Summary	Field Installation of Hypalon Seal Wrap				
Products Affected	TSI Gen 2 Doors				
Key Word Tags	TSI, Gen 2, Seal, Wrap, Retro, Hypalon				
Tools/Equipment (If Required)					
Parts/Materials (If Required)	K1170796-0 BRUSH SEAL WRAP - GEN2				
Related Media					
Author	Mike Burzlaff	Issue Date	10/20/17	Status	Active

In order to help prevent cold air infiltration from the warm side to the freezer side on Turbo Seal Insulated Gen 2 doors, Rytec is implementing a wrapped header seal to better handle the temperature differentials.

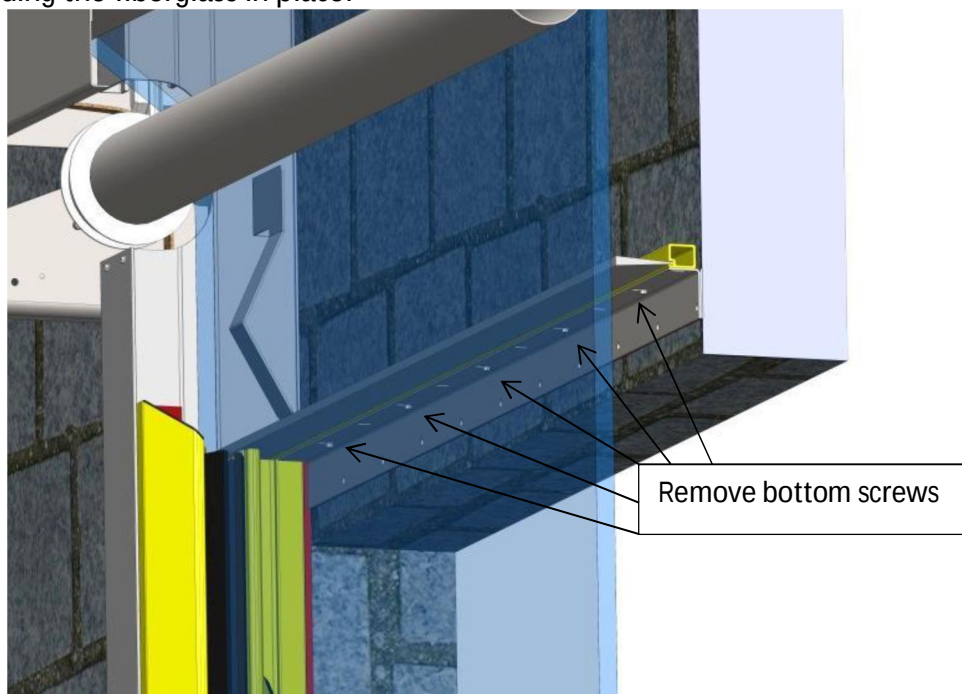
The current fiberglass seal will need to be removed to install the Hypalon wrap.

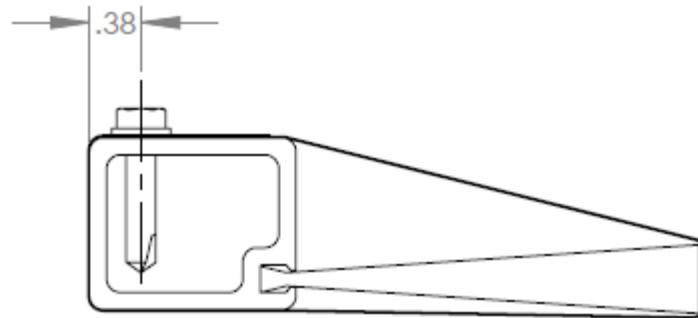
The mounting angle iron can remain on the wall. Remove the screws from the bottom of the angle iron that are holding the fiberglass in place.

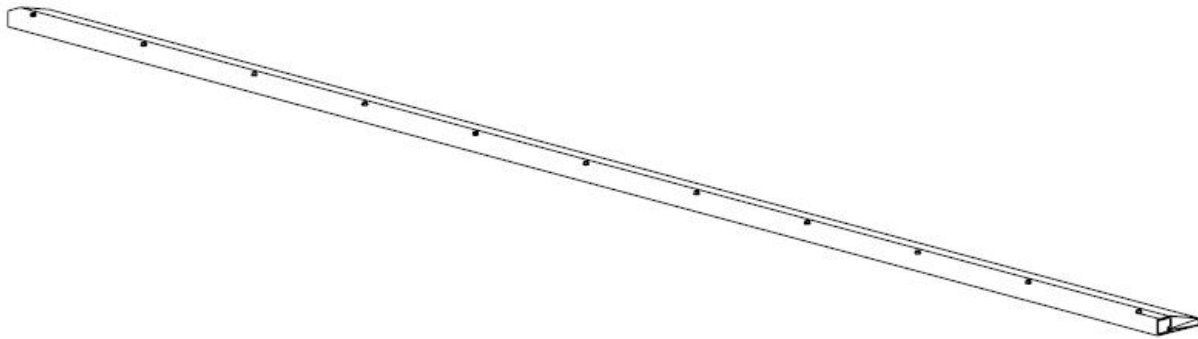
The seal is wrapped around the fiberglass and brush to create a loop. Use the provided screws to secure the brush to the top side of the fiberglass.

Starting at about 2 ¼" from one end of the fiberglass, space the screws every 8"-10" the length of the retainer.

The other edge of the seal will be sandwiched between the mounting angle on the wall and the retainer.
